Transmitting in accordance with
10 CFR 50.30 Request to amend Appendix A
of Facility Operating Licenses DPR-31
And 41 to satisfy a commitment made
in RO 50-250/77-5 of 5/2/77.

Re: Turkey Point Units 3 & 4
Docket Nos. 50-250 and 50-251
Proposed Amendment to Facility
Operating Licenses DPR-31 and DPR-41

This proposal is being submitted to satisfy a commitment made in Reportable Occurrence report 250-77-5 of May 2, 1977, (attached). The proposed change is described below and shown on the accompanying Technical Specification page bearing the date of this letter in the lower right hand corner.

Fig. 2.1-1. Reactor Core Thermal and Hydraulic Safety Limits, Three Loop Operation

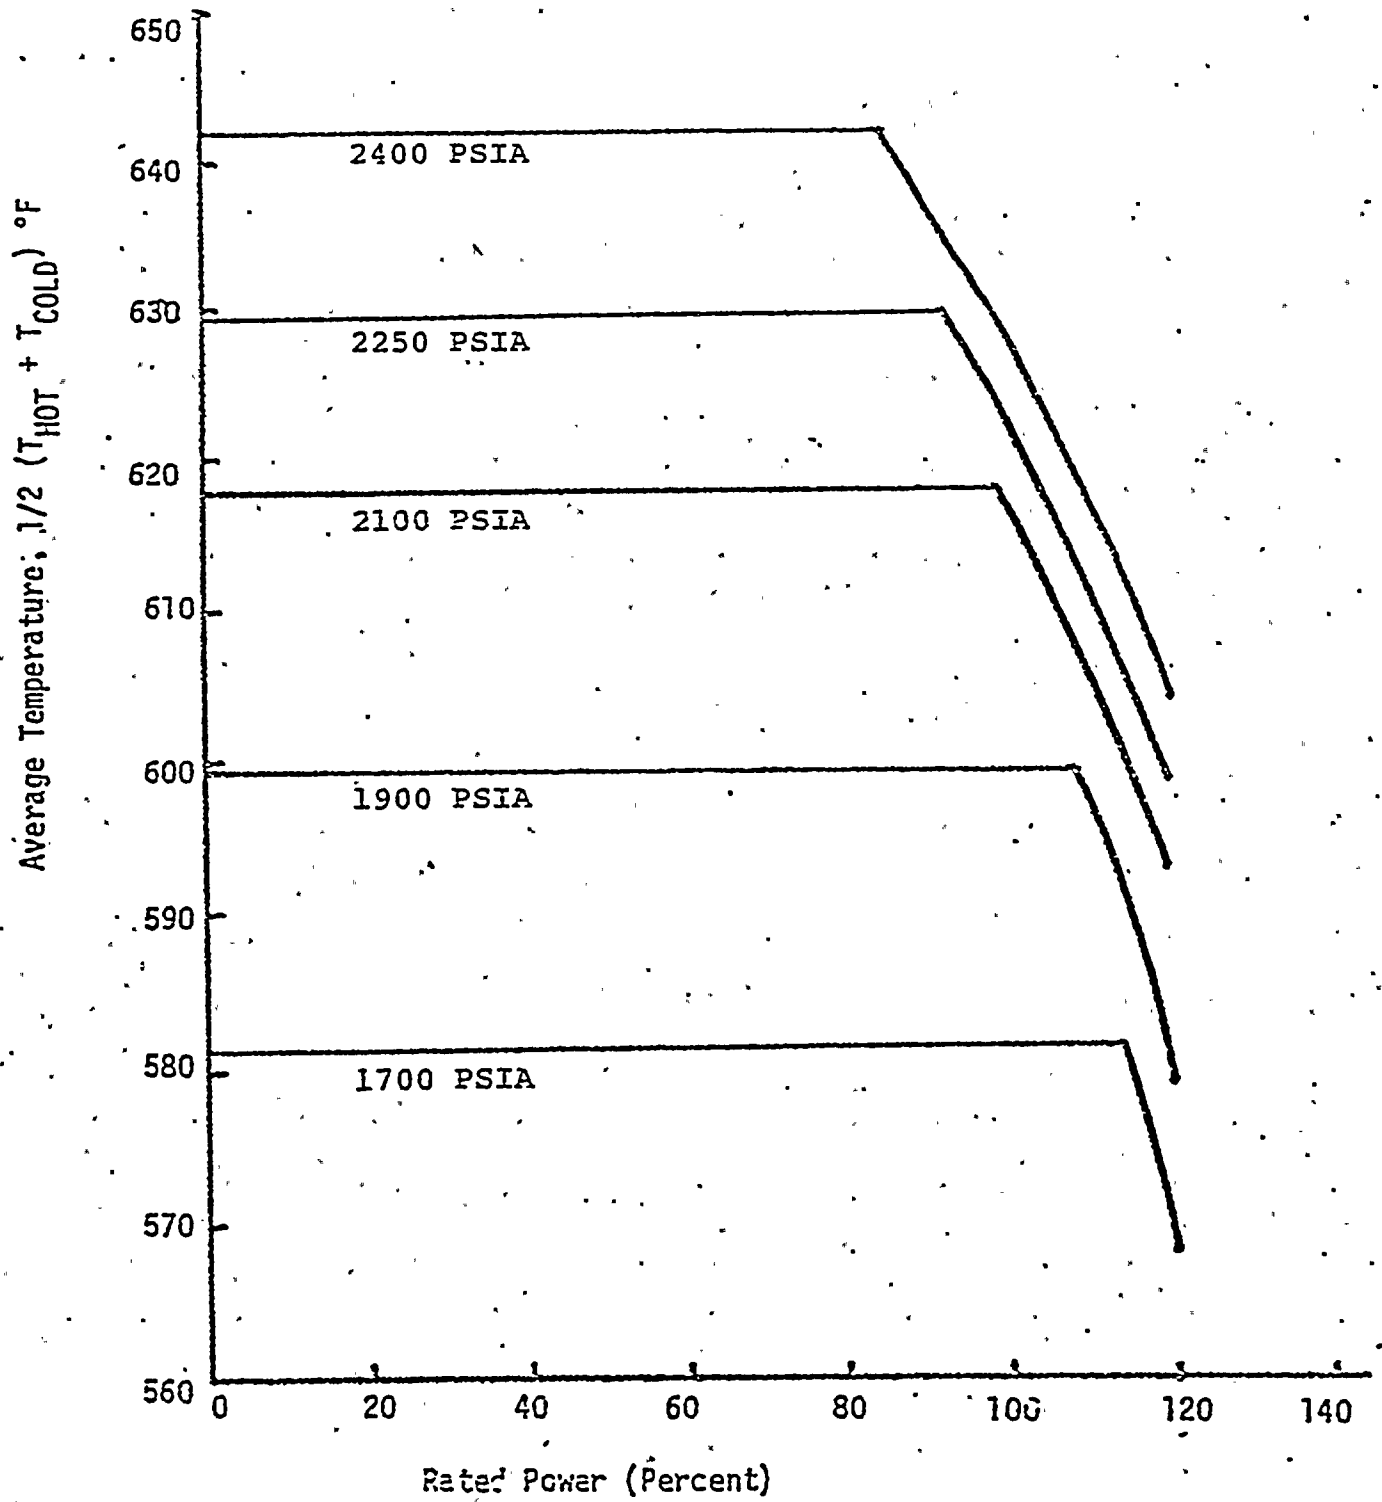
An analysis performed by our NSSS vendor has resulted in a corrected Figure 2.1-1 applicable at the licensed steady state reactor core thermal power output of 2200 Mwt.

power output. However, they recently advised us that the specific number being used for analytical work was 2192 Mwt. An analysis performed at 2200 Mwt showed that, in a single case, it would be necessary to make a minor administrative change to a Technical Specification (Figure 2.1-1). Figure 2.1-1 has been adjusted downward the necessary amount (approximately 1.5°F) to compensate for the correction. A proposed Technical Specification amendment will be submitted to the NRC to request a formal change correcting Figure 2.1-1.
